# Access Compliance Report

Intersection ID: 14659	Main Street: E_WORTHINGTON_AV	Cross Street: SPRINGDALE_AV	Location:	N
ADA ID: 42B6A205271F	Ramp Type: Perp	Initial Pass/Fail: Fail	Overall Compliance: No	Severity Score: 35

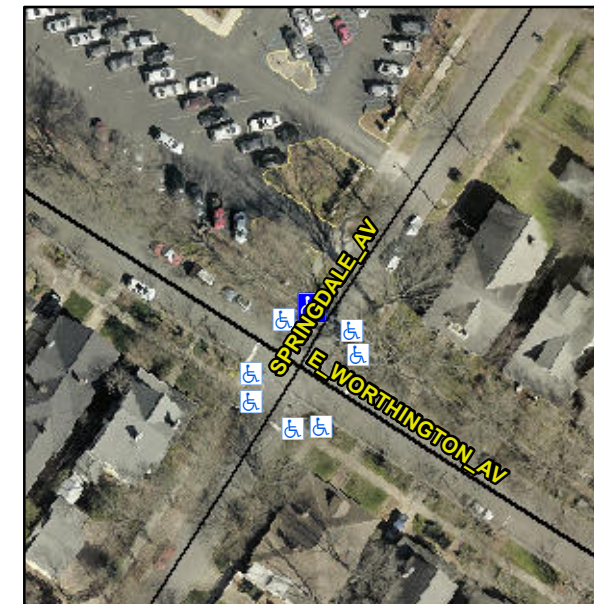
**Not Found, R304.5.1, R304.2.2, R304.5.3**

Compliance	Description	Data	Compliance	Description	Data
N/A	Ramp Length (in)	51.0	No	Ramp Slope (%)	12.8
No	Ramp Width (in)	36.0	No	Ramp XSlope (%)	2.5
N/A	Flare Type LT	N/A	N/A	Flare Type RT	N/A
N/A	Flare Slope LT (%)	N/A	N/A	Flare Slope RT (%)	N/A
N/A	Flare Traversable LT?	N/A	N/A	Flare Traversable RT?	N/A
N/A	Landing Length (in)	N/A	N/A	DWS Provided?	N/A
N/A	Landing Width (in)	N/A	N/A	DWS Contrast?	N/A
N/A	Landing Slope (%)	N/A	N/A	DWS Length (in)	N/A
N/A	Landing X Slope (%)	N/A	N/A	DWS Full Width?	N/A
N/A	Landing Curb? (Y/N)	N/A	N/A	DWS Offset (in)	N/A
N/A	Shared Landing?	N/A			
N/A	Gutter Ponding?	N/A	N/A	Gutter Slope (%)	N/A
N/A	Gutter Lip Ht (in)	2.0	N/A	Gutter X Slope (%)	N/A
N/A	Painted X Walk1?	No	N/A	Painted X Walk2?	N/A
	X Walk 1 Direction	To SE		X Walk 2 Direction	N/A
N/A	X Walk 1 Width (in)	N/A	N/A	X Walk 2 Width (in)	N/A
	X Walk 1 Slope (%)	6.4		X Walk 2 Slope (%)	N/A
	X Walk 1 X Slope (%)	2.1		X Walk 2 X Slope (%)	N/A

**Remove & Replace Entire Ramp.**
